PLANNING RESPONSES
SUNLIGHT HOUSE
APRIL 2023

EXTERNAL ALTERATIONS

INTERNAL ALTERATIONS

LEVEL 01 - EXISTING

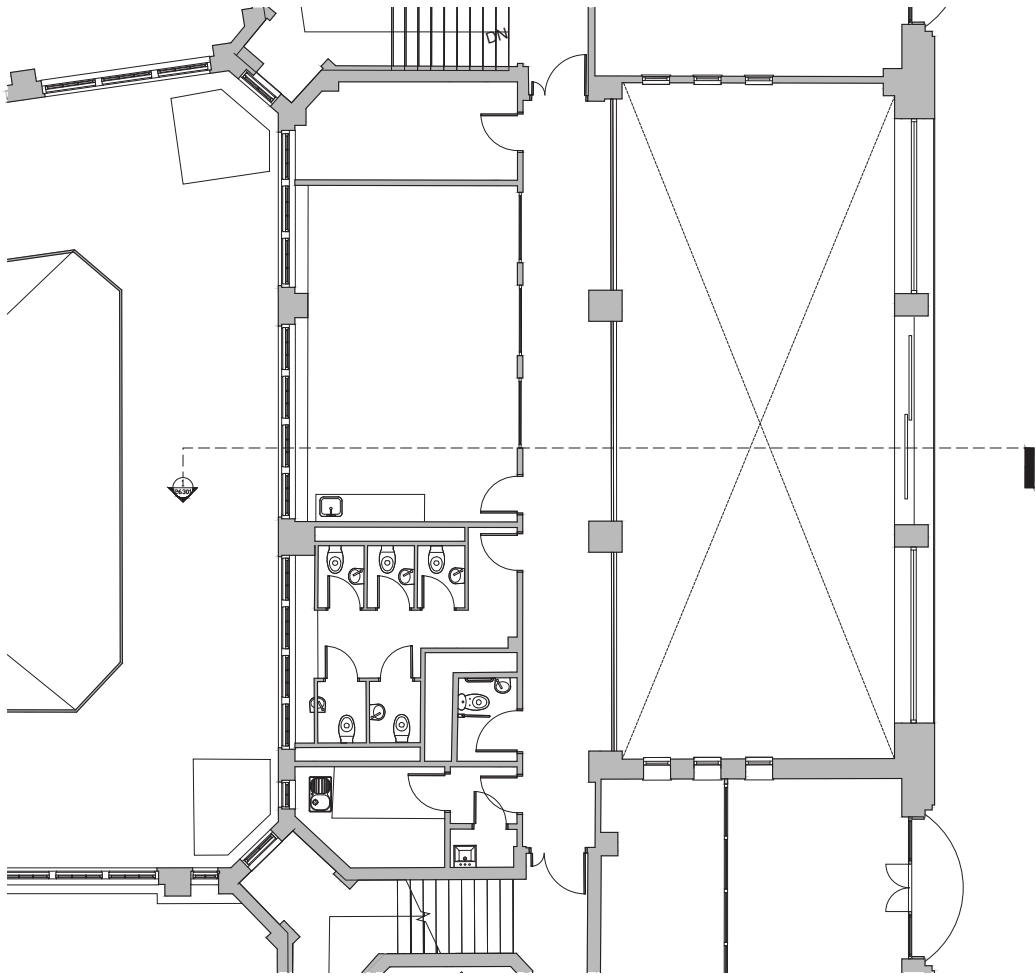
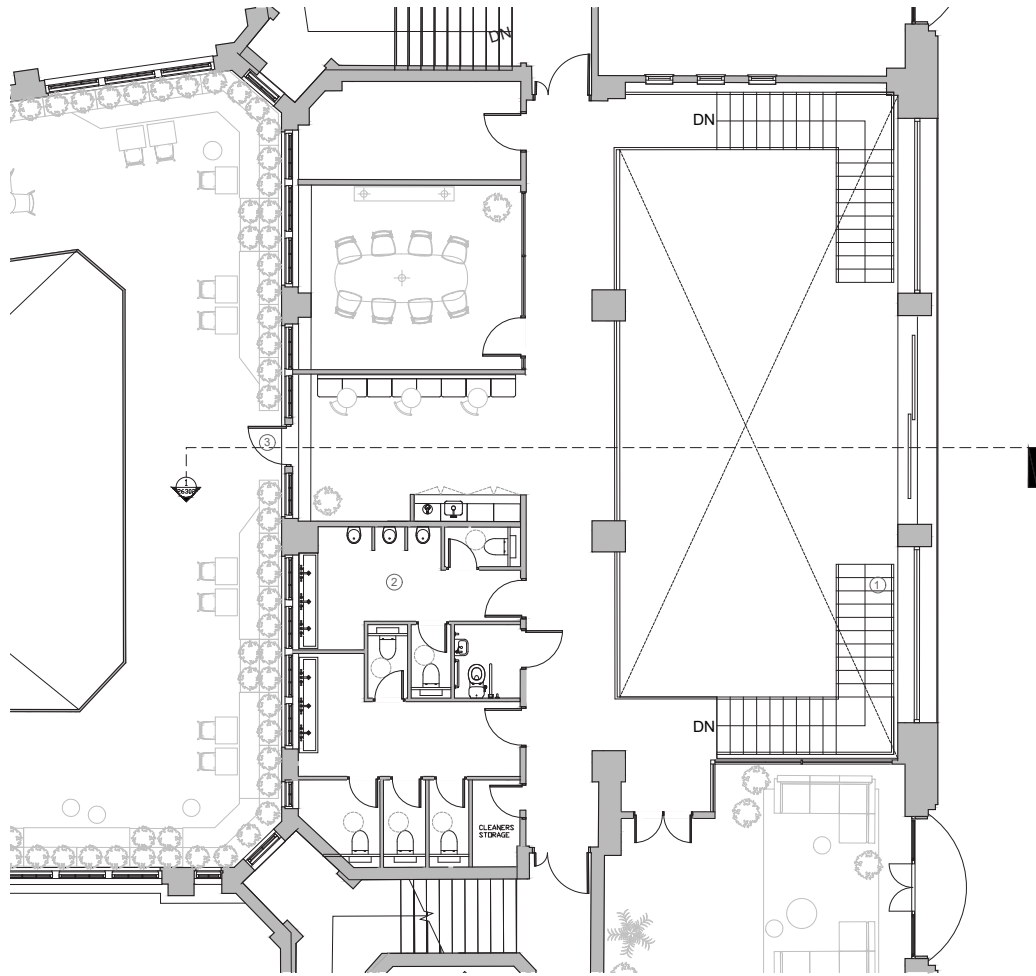
The proposed floorplan of the section of mezzanine above the grand entrance would fail to remove the incongruous modern subdivision of the original window frame. It would add another partition to the existing window frame. This needs to be reviewed again including whether the existing mullion subdivision should be removed with new partitions accommodated to the existing pillars. The kitchen unit in the proposed corridor should be relocated to allow a better appreciation of the entrance into the lightwell.

We are limited somewhat by the existing back of house room extents which is serving in-situ tenants throughout the works.

While we have introduced a partition to form the meeting room, we feel this is balanced with the positive contribution of introducing the access door to the external space. We have also placed the partition here as it will be perceived as a central door internally with a window either side - given the sash sets are 4 windows currently (please see images overleaf)

LEVEL 13 - WITH THE WALL AND CORRIDOR
REMAINING IN SITU

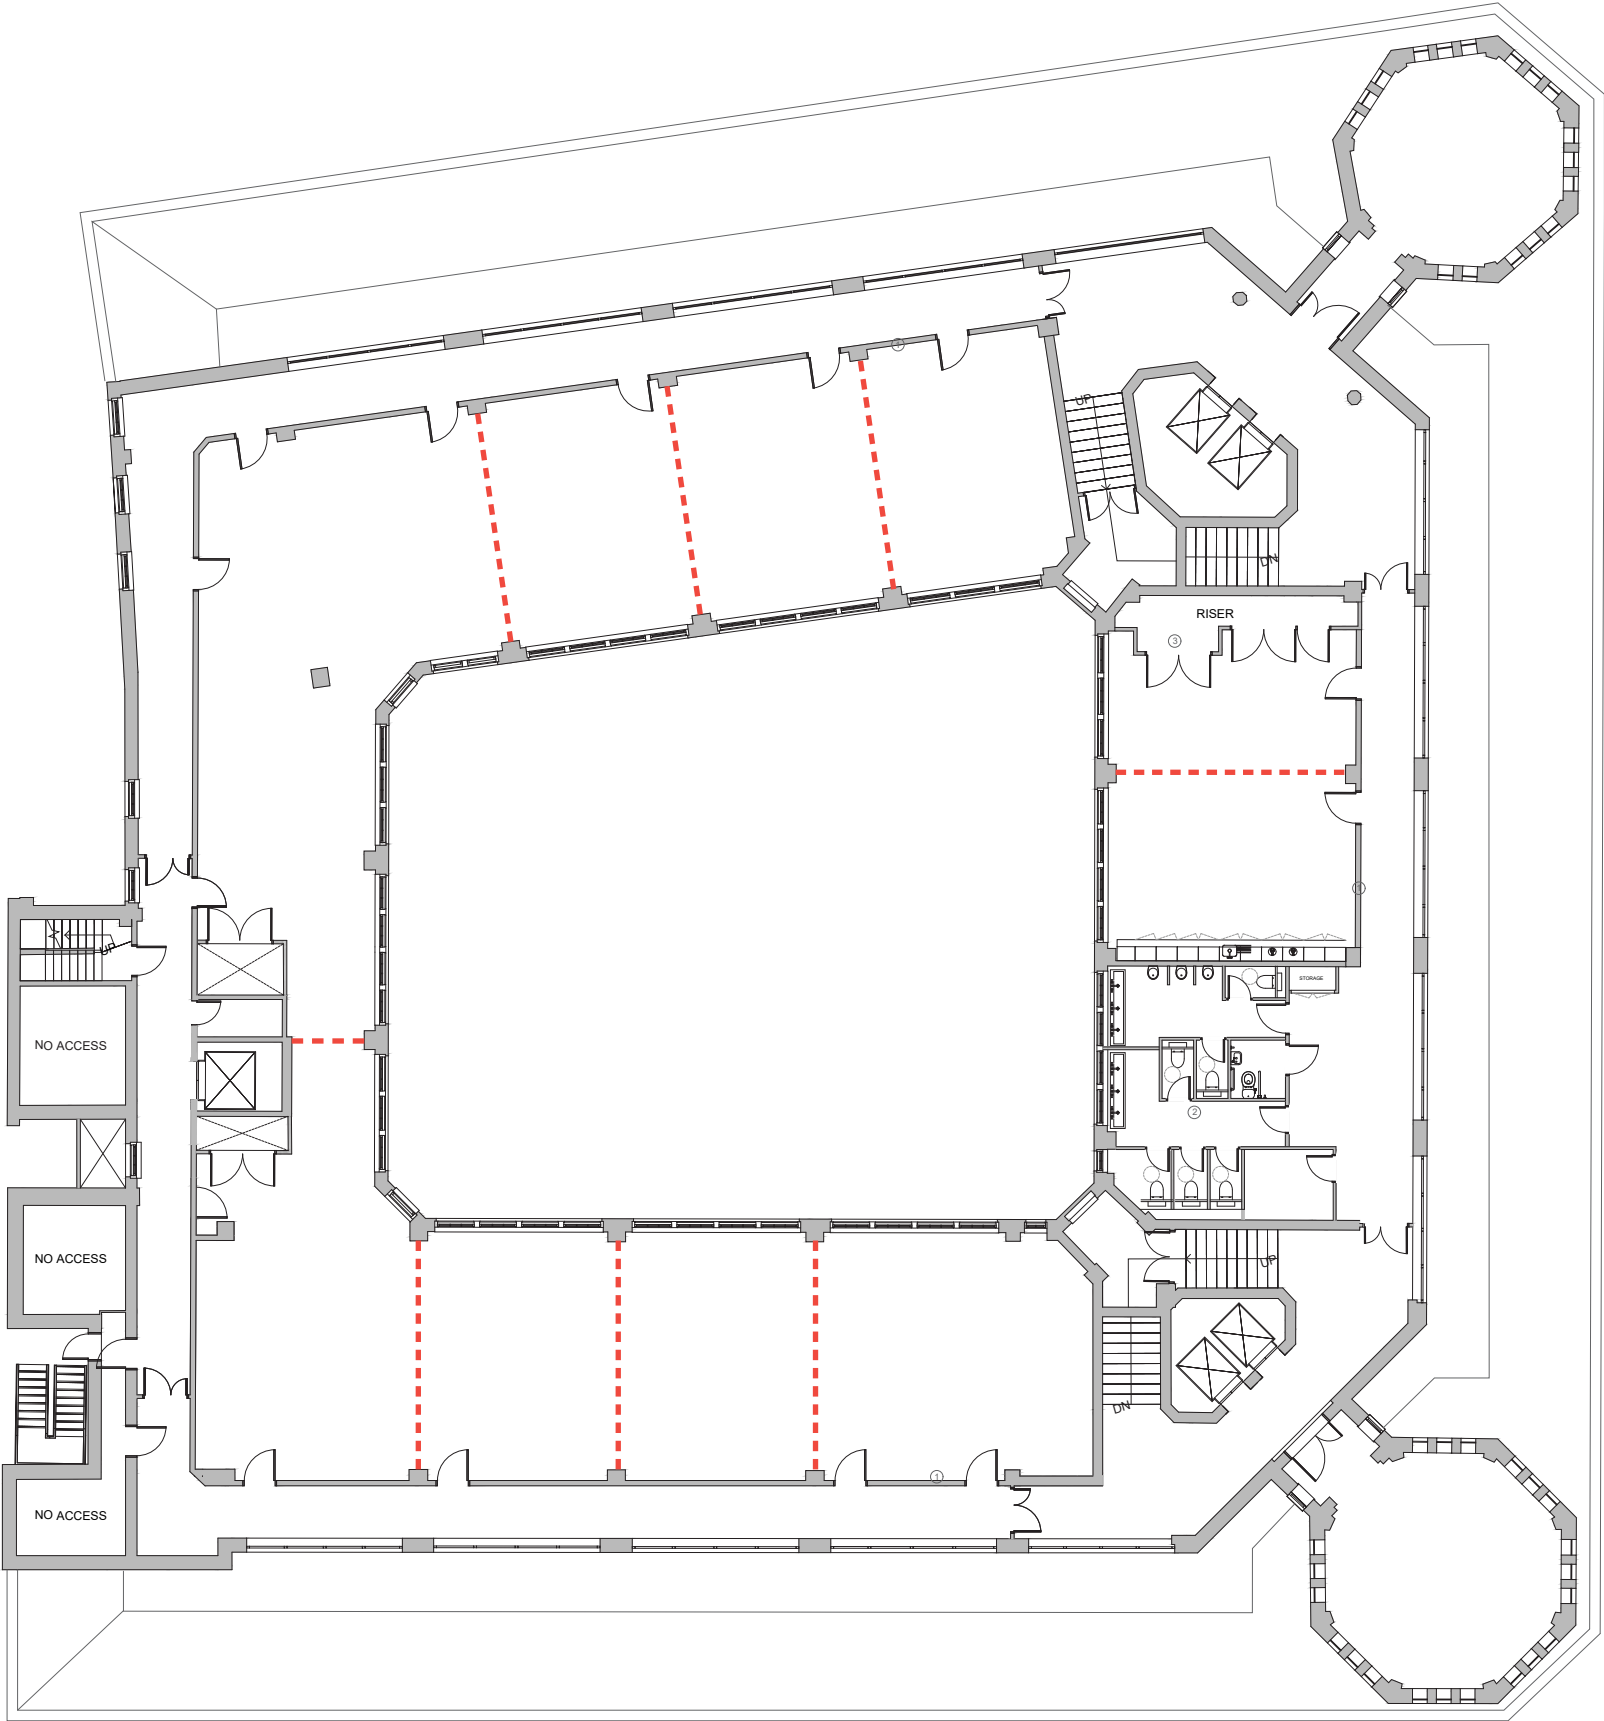
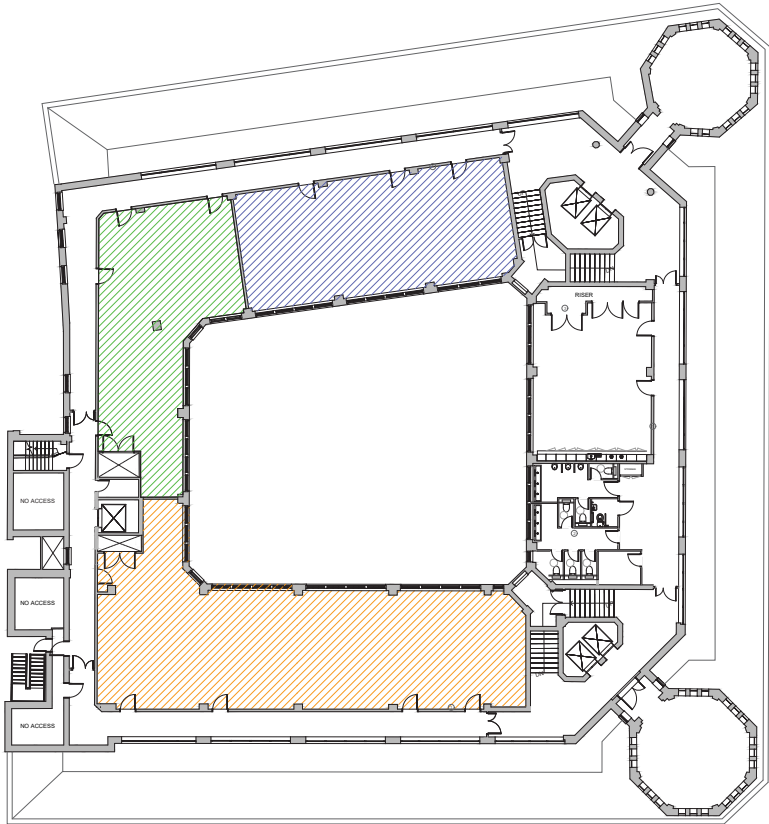
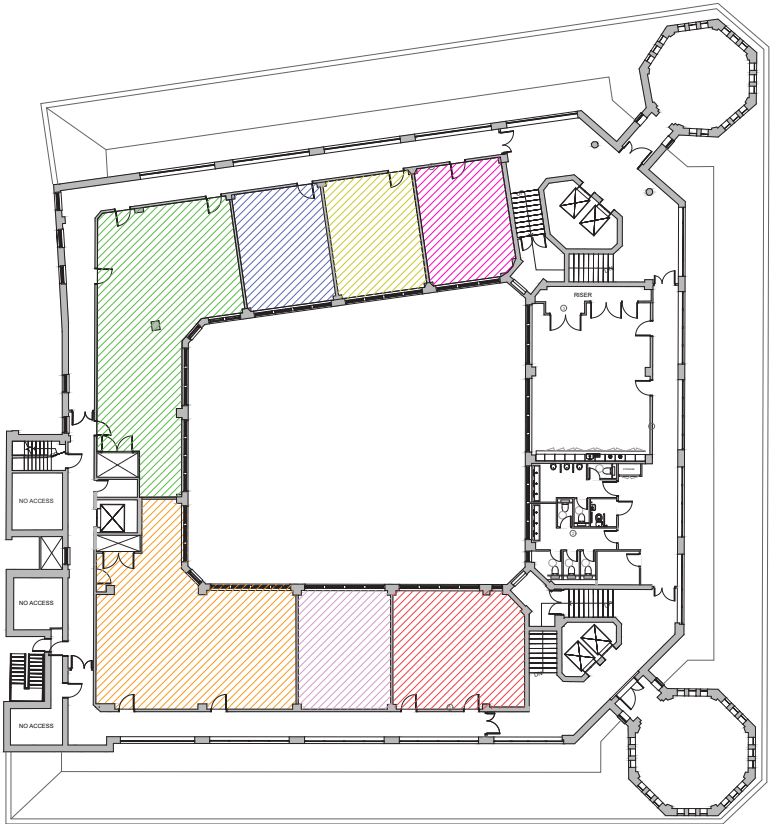
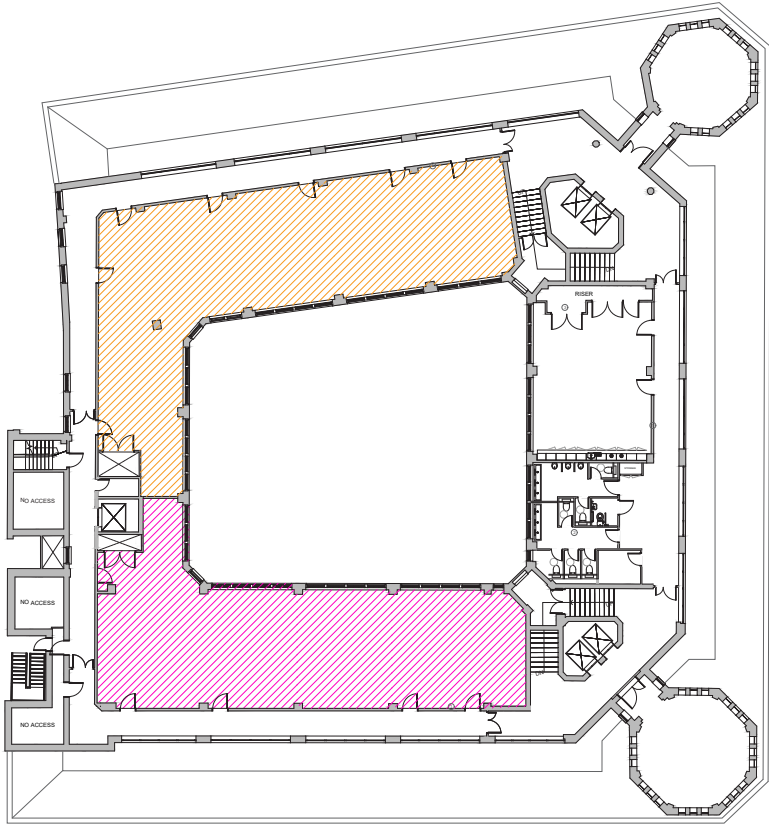
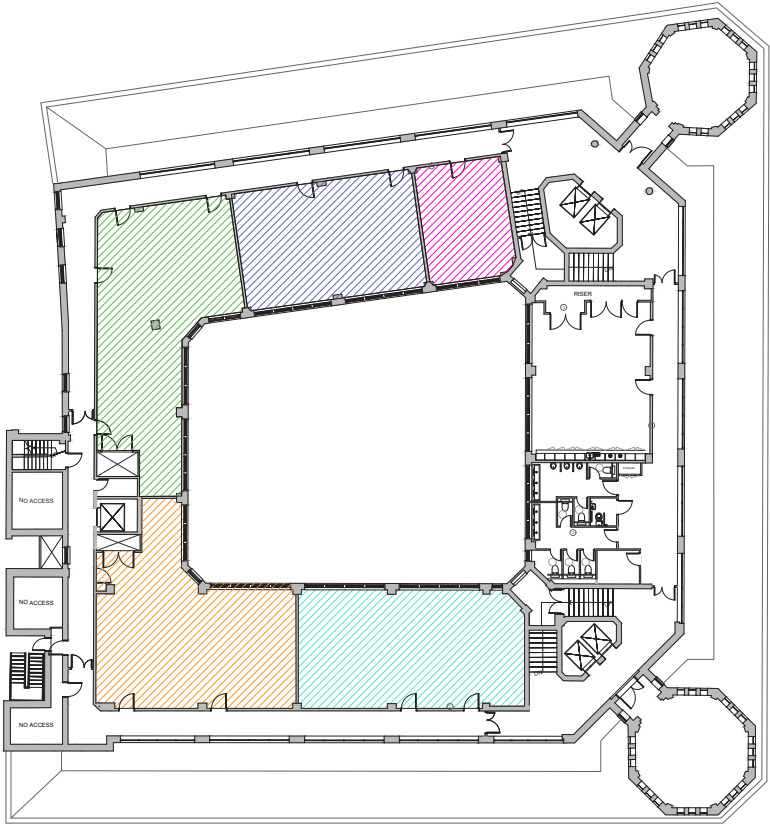
Can you provide further commentary for this works including justification for subdivision at the lower levels due to a need to create smaller unit when this floor provides smaller floor plates because of the wall to the corridor.

Additional leasing agent commentary has been provided on the feedback regarding the floor lettability. The main issue stemming from a U shaped floorspace internally with no subdivisions not requiring an external corridor, with the narrow space difficult to use or envision using.

Following further discussion with Officers and the client team it is now proposed that the corridor wall remains in-situ.

Floor would be split into no more than 7 key tenancies with small meeting room/shared space/kitchen between main cores and rotunda meeting rooms.

LEVEL 13 - EXISTING

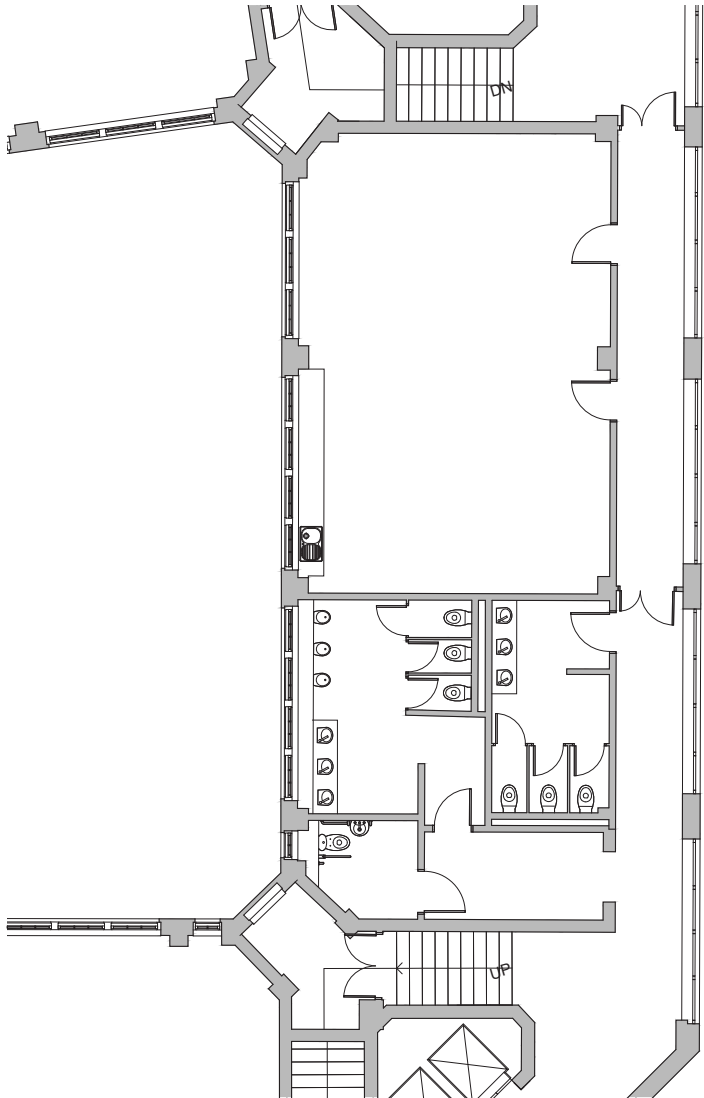
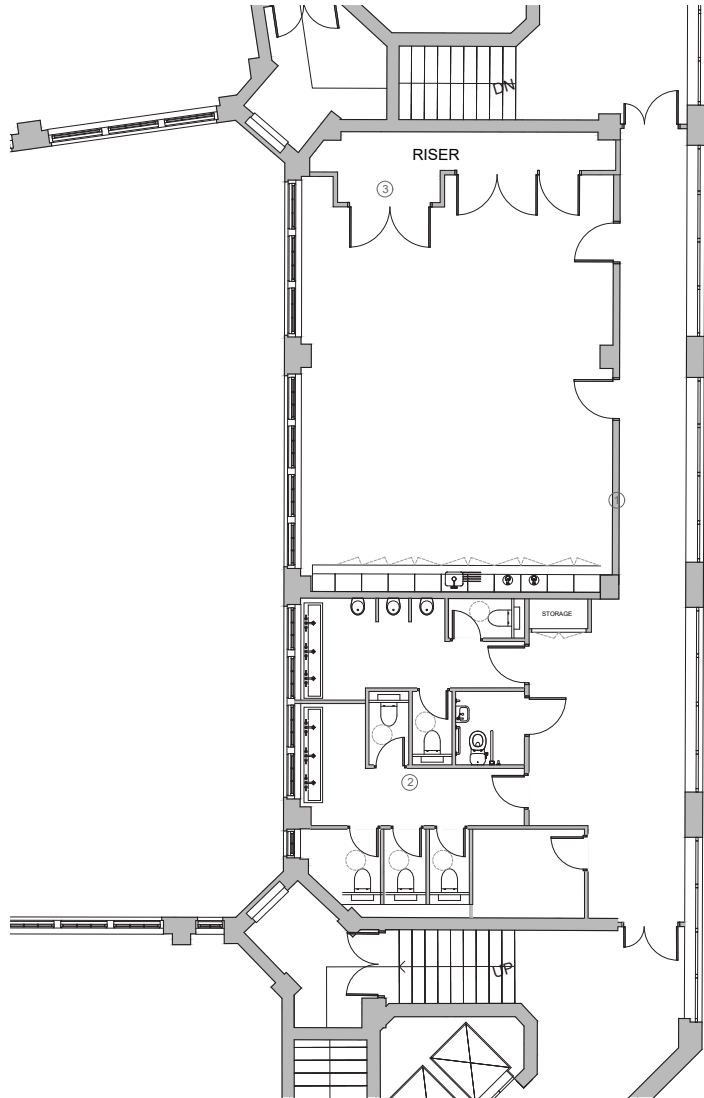
The works to the plant and maintenance room appear to show new partitions that would cut across the window frames. A plasterboard soffit is also proposed which would block the impressive barrel vaulted ceilings and the skylight. The proposal needs to be amended in this regard. Further needs to the scope of the repair in this area needs to be provided to help justify the works. No details for instance have been provided with regards to unblocking covered rooflights and they are not shown on the reflected ceiling plans. Will the original cupboards in this area be reinstated?

We have now corrected our incorrectly labelled drawing and amended the drawings to pull the riser back from the window.

The windows are actually just dirty - we will need to consult with a specialist about the best way to clean these given limited access. We would welcome these works being conditioned if necessary.
